# STATE OF ALASKA

Re: Former Chevron Valdez Terminal, Ground Water Quality Results Monitoring  
Report, Review

The department has completed review of the Draft February 1992 Development of Risk-Based Groundwater Cleanup Levels for the Former Chevron Terminal Site in Valdez, Alaska (tank farm/bulk plant) and your May 29, 1992 letter regarding cleanup levels at the former Chevron Bulk Terminal in Valdez. The proposed groundwater cleanup level of 0.200 mg/l benzene is conditionally approved dependent on Chevron's compliance with the conditions described below:

PETRO STAR, INC.  
 TESORO BULK FUEL PLANT  
 VALDEZ, ALASKA  
 LEVEL II ESA  
 CONTAMINANT PLAN  
 FIGURE 5

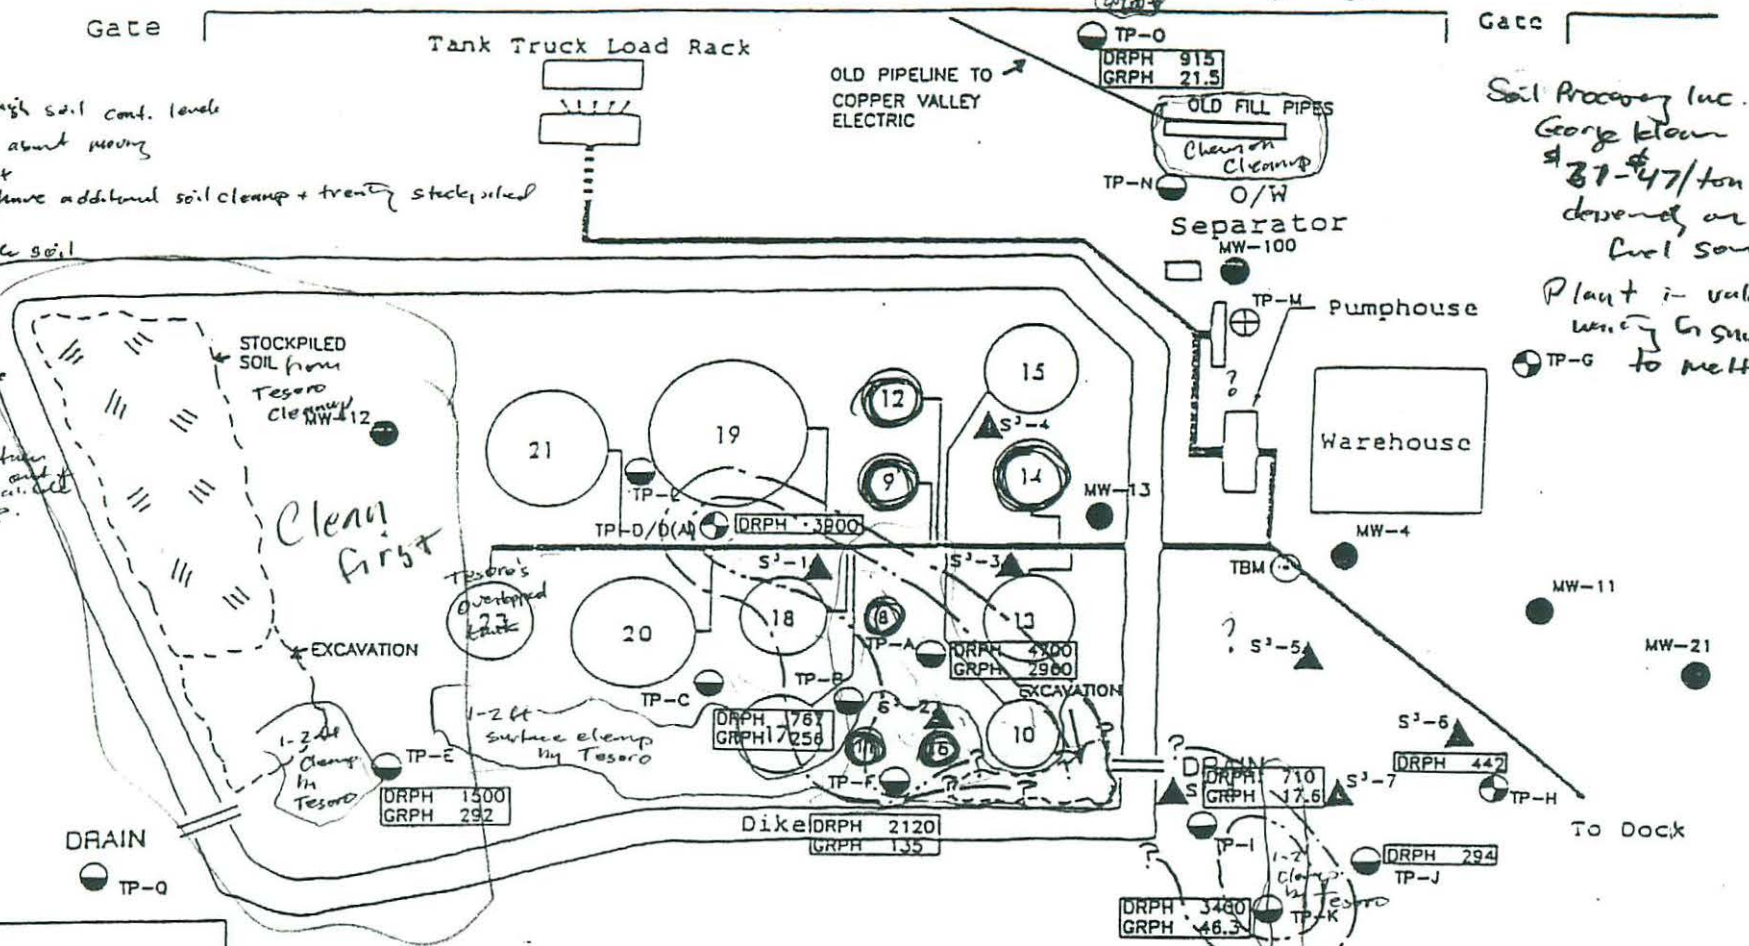
Re-evaluated progress at site relative to the review of RZA part Egan Drive

1. RZA established high soil cont. levels
2. Wait gone tanks about moving tanks to west
3. Chevron & Tesoro have additional soil cleanup + treating stockpiled soil
  - a. cleanup accessible soil and place tanks
  - b. remove tanks in eastern area out of service as new tanks installed
  - c. "immediately" treat unmet tanks and of soil to fill cell cleanup.
